**SPARTANBURG COMMUNITY COLLEGE – TYGER RIVER BUILDING COSMETOLOGY  
RENOVATION**

**OSE PROJECT # H59-N306-JM | ARCHITECTS PROJECT # 653251**

## RESPONSE TO PRE-BID QUESTIONS

**LOWER LEVEL DEMOLITION PLAN (ALTERNATE-1)**  
1/8" = 1'-0"

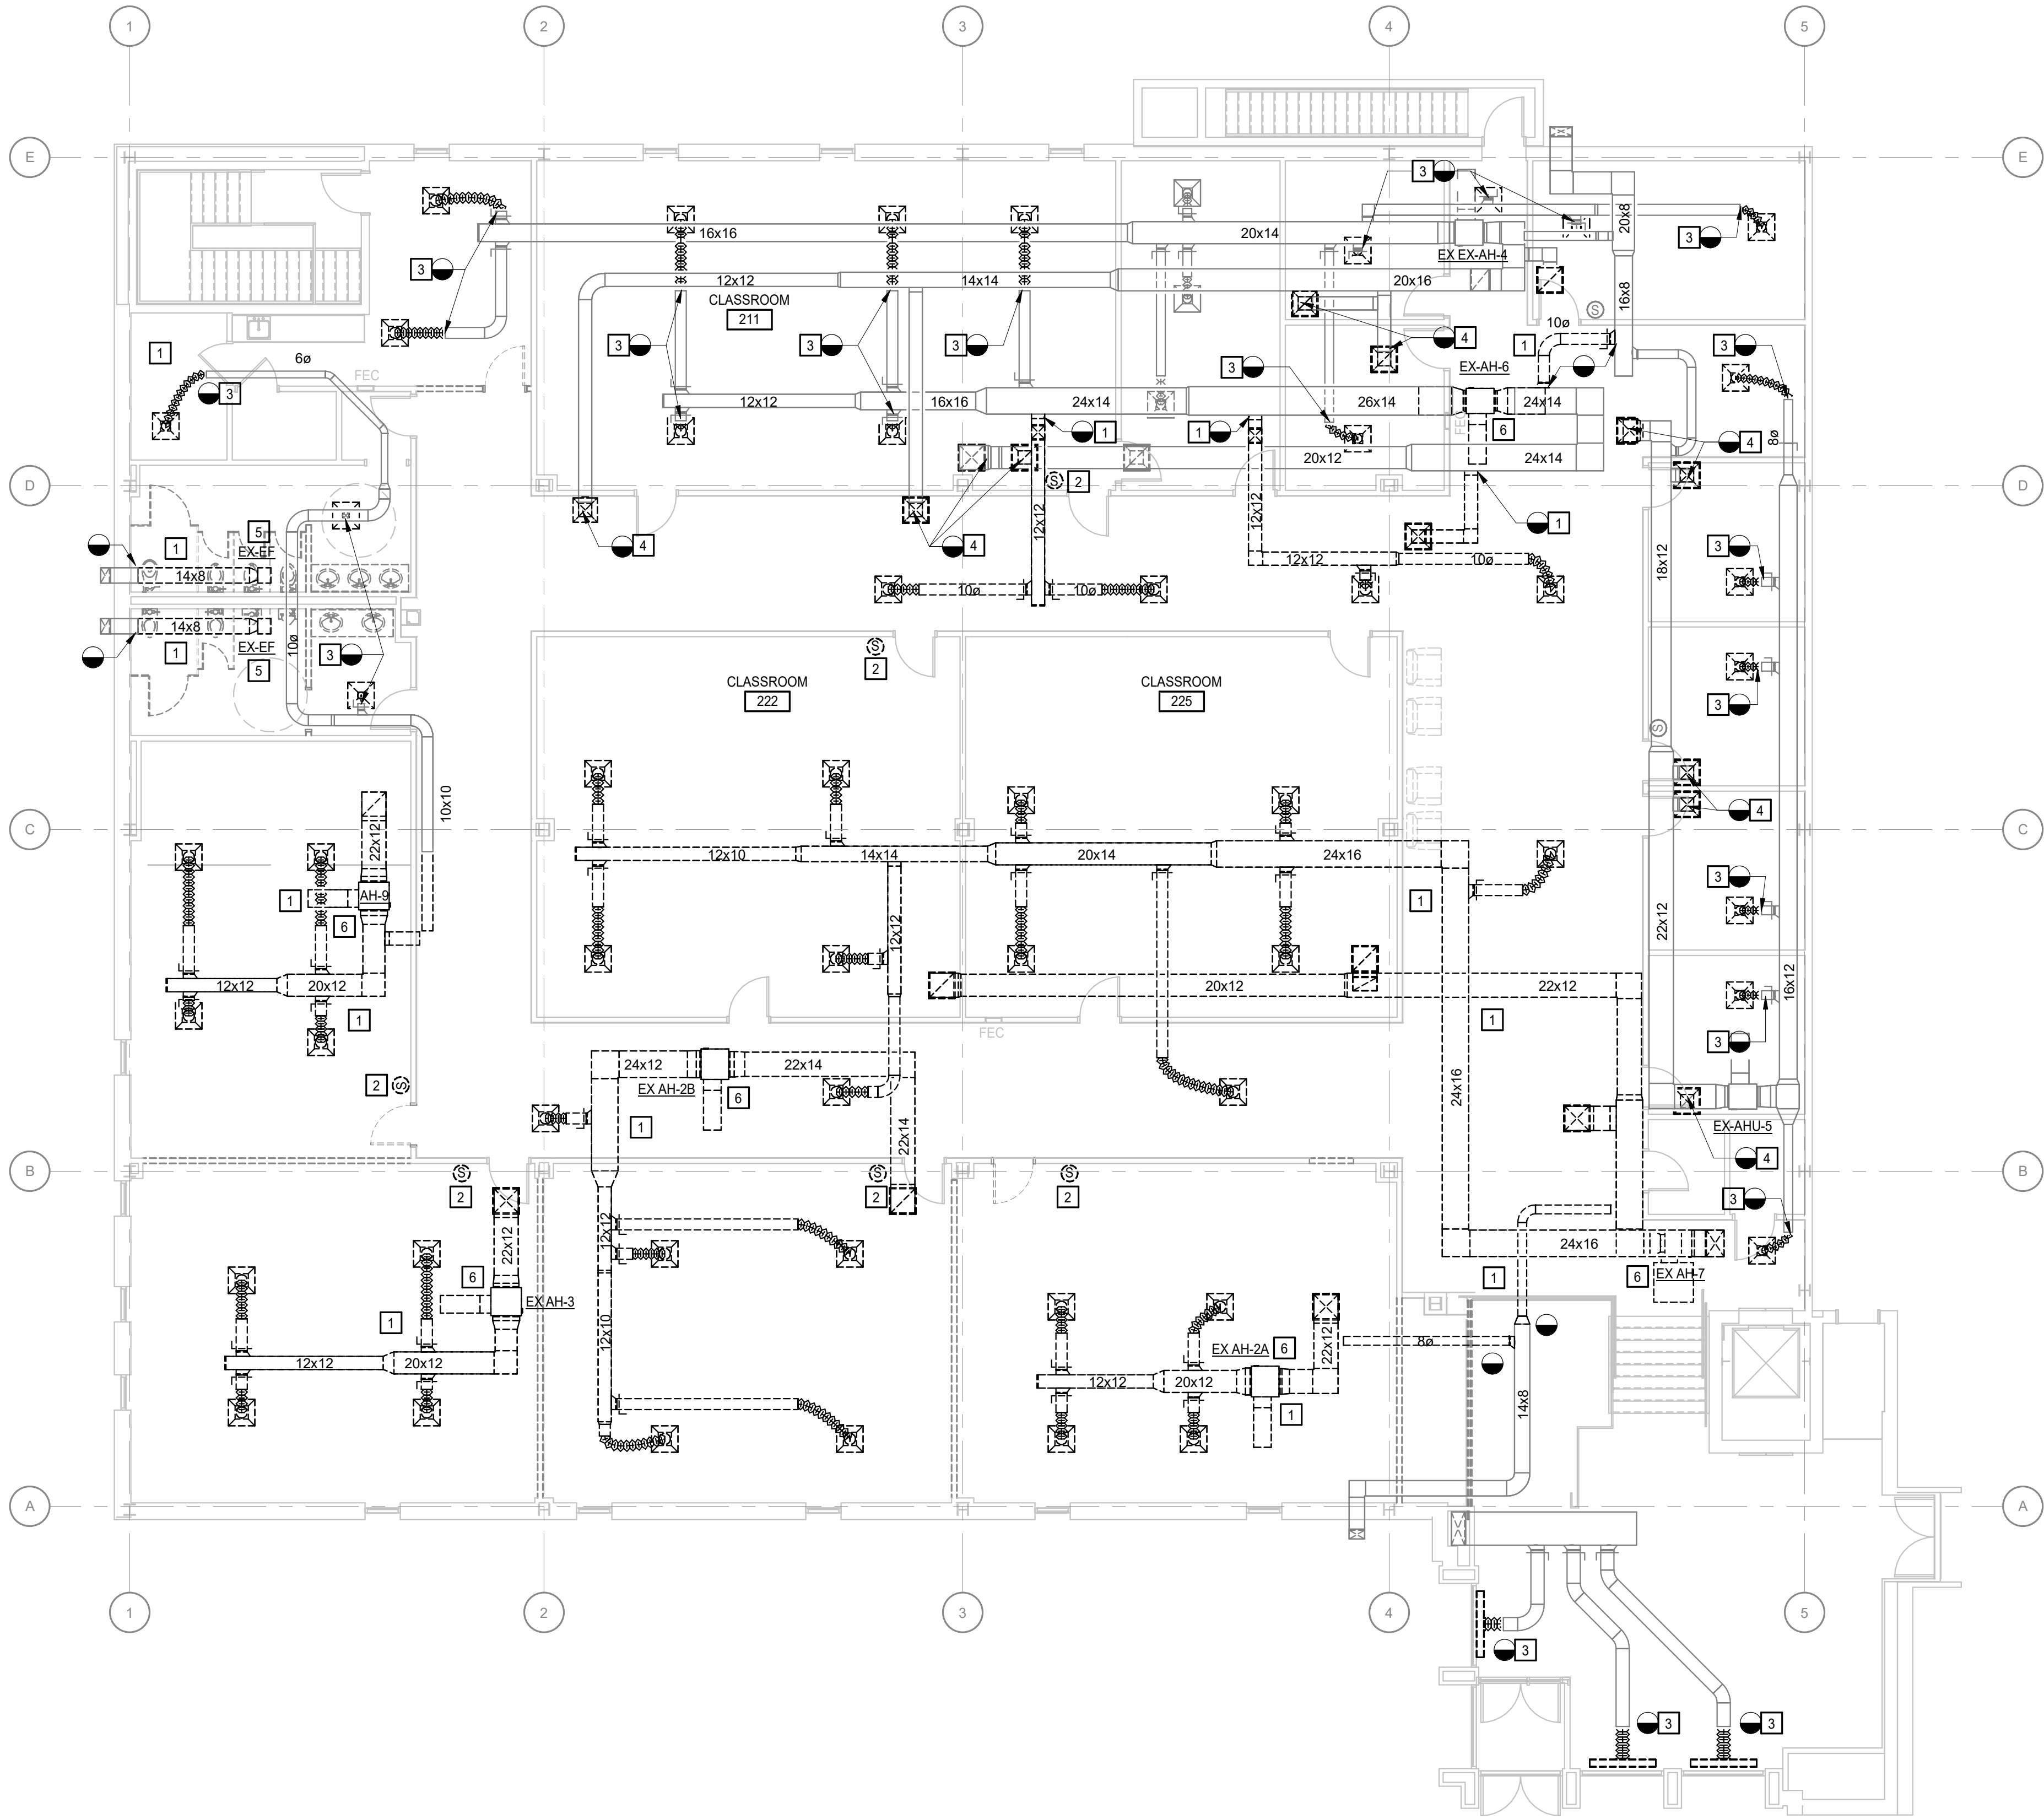
1. Mechanical drawings have been revised to indicate items to be removed during demolition are to be salvaged and turned over to the owner, as requested by the owner.

A. ALL EXISTING EQUIPMENT AND CONTROLS, CONTROLLER, VALVES AND THERMOSTATS ETC. NOTED TO BE REMOVED SHALL BE SALVAGED AND PRESENTED TO THE OWNER FOR DETERMINATION OF WHAT EQUIPMENT AND CONTROLS WILL BE RETAINED BY THE OWNER AND WHAT WILL BE DISPOSED OF.
